SB-10056886-4101

Title: 8,000 LBS Front Suspension Lean Correction

Applies To: TerraStar, DuraStar and AE Bus

Spacer 2512808C1

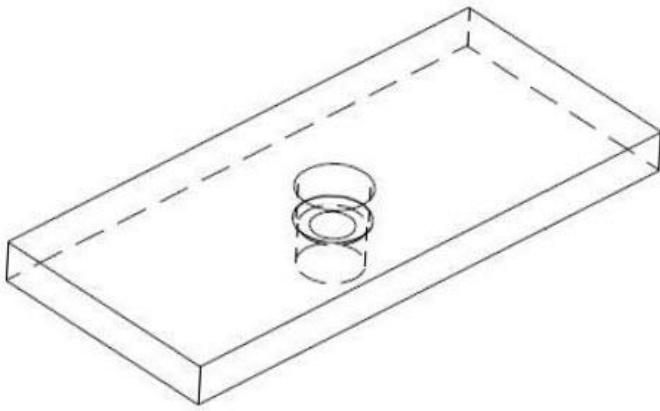
Certain TerraStar, DuraStar, and AE Bus models built with a 8,000 LBS front suspension, may experience a chassis lean causing the left front(driver side front) of the vehicle to be lower than the right front(passenger side front). This is caused by a stack up of different component locations on the truck, which cause a weight bias to one side. When this condition is present on a truck equipped with IROS rear air ride suspension, the right rear can be higher than the left rear.

- Replacing a leaf spring for a TerraStar, DuraStar, or AE bus will not correct a lean condition where the left front is lower than the right front.

1. Park the truck on flat, level ground
2. Using a tape measure, measure the front of the truck from the frame rail to the ground
3. If the left front is lower than the right front by a measurement that is greater than 3/8", then a spacer needs to be installed

1. Block the wheels of the truck with wheel chocks
2. Jack up the front of the truck, and support the chassis with jack stands placed under the frame rails
3. Using a floor jack, support the front axle to keep it from falling once the U-Bolts have been removed
4. Remove the U-Bolts
5. Lower the jack to create enough space between the spring and the axle to insert the spacer
6. Insert the spacer with the tab pointed down. Ensure that the lower tab fits into the hole in the axle, and the center pin tab of the spring fits into the spacer. Raise the floor jack to take up all space between the spacer, the axle, and the spring
7. Install the new U-Bolts. In a diagonal pattern, torque the U-Bolts in 50 FT-LBS increments
8. Torque U-Bolts to a final torque value of 260 FT-LBS to 300 FT-LBS(192 N·M to 222 N·M)
